MOD 4 - EASTLAKES SHOPPING CENTRE - RESPONSE TO KEY ISSUES

Table 1 Response to DPIE Key Issues for North Site

FIGURE 5 – PROPOSED OPTION 1 EASTERN PLANTER (SOIL VAULT)

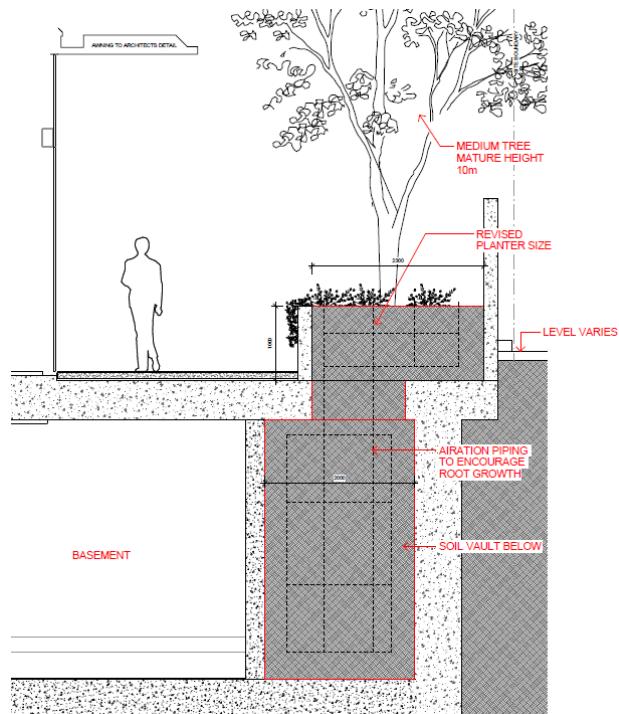
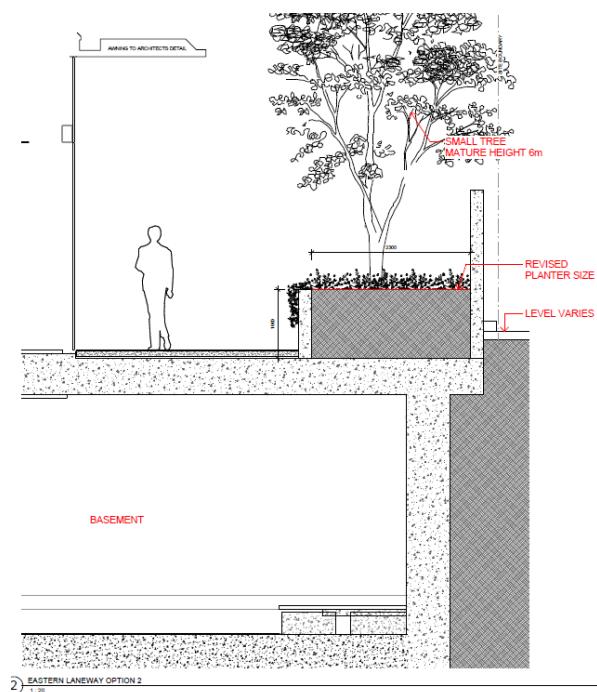
<p>3.3 The provision of a dense landscape green edge at the eastern entrance to the site from Evans Avenue was important in the assessment and determination of the original application and in the assessment of MOD 1. The plans should be amended so that the quantum and quality of landscaping will not change in this location.</p> <p>At the laneway entrance, Option 1 is our preference, although the planter must extend to the street and bicycle racks relocated.</p>	<p>As part of detailed design and coordination with the early work site contractors, it has become apparent that due to the basement extent and the below ground conditions, the deep soil available between the basement wall and the boundary is not sufficient to provide soil volumes for the specified (and approved) trees along the eastern elevation.</p> <p>The early works excavation found the site soil to be soft beach sand that required restraint at all times to prevent collapse. Sheet piling was required along the eastern boundary to prevent collapse to the neighbouring driveway. It was also discovered the driveway itself has not been constructed on a concrete subbase and the edge at the property boundary is unsupported. It is also disturbed by the tree roots that have grown to lift the paving surface.</p> <p>It has also been determined as part of the detailed design process that due to the narrow driveway, a kerb needs to be introduced adjacent to the boundary wall to prevent vehicles impacting the boundary wall. Therefore, due to the existing ground conditions, the design of the neighbour's driveway and the need to construct a concrete kerb, reinstating the planter on the eastern side of the wall is not feasible.</p> <p>Notwithstanding, Turf Design Studio have prepared two design options in an effort to increase landscaping along this boundary while balancing the constraints described above. The options include:</p> <ul style="list-style-type: none"> - Option 1 (soil vault below) – 1 x small tree of mature height of 5m and 2 x medium trees with mature height of 10m. - Option 2 – 4 x small trees of mature height of 5m. <p>The project team advises that Option 1 best addresses the constraints of the as built condition and the design intent for dense landscaping at the eastern entrance. This design provides 86m³ of soil volume at the eastern entrance which is sufficient for two 10m high trees (35m³ each) and one 5m high tree (9m³) as identified in the ADG.</p> <p>Although the two medium sized trees in the alternative design are fewer than the six small trees shown in the MOD 1 submission this is</p>

Key Issue	Response
	<p>considered a reasonable reduction given that a species with a larger mature height have been selected.</p> <p>DPIE provided preliminary feedback which suggested they also preferred Option 1 but requested the planter extend to the street and bike racks relocated. The proposal has sought to extend the planter to the street as far as possible. However, it is noted that a service access hatch to the chiller plant below exists in the eastern laneway which restricts the planter proceeding beyond the point shown in the plans to ensure access and working area is maintained. It is further noted that this location is the most optimal for bicycle parking on the north site and there are no other viable options to locate bicycle parking apart from Evans Avenue and the basement which is considered to result in a poor accessibility and public domain outcome.</p>
	<p>A comparison between the approved eastern elevation and the two options for consideration are illustrated below and in the Landscape Plans submitted at Appendix C.</p> <p>FIGURE 4 – APPROVED EASTERN PLANTER</p>
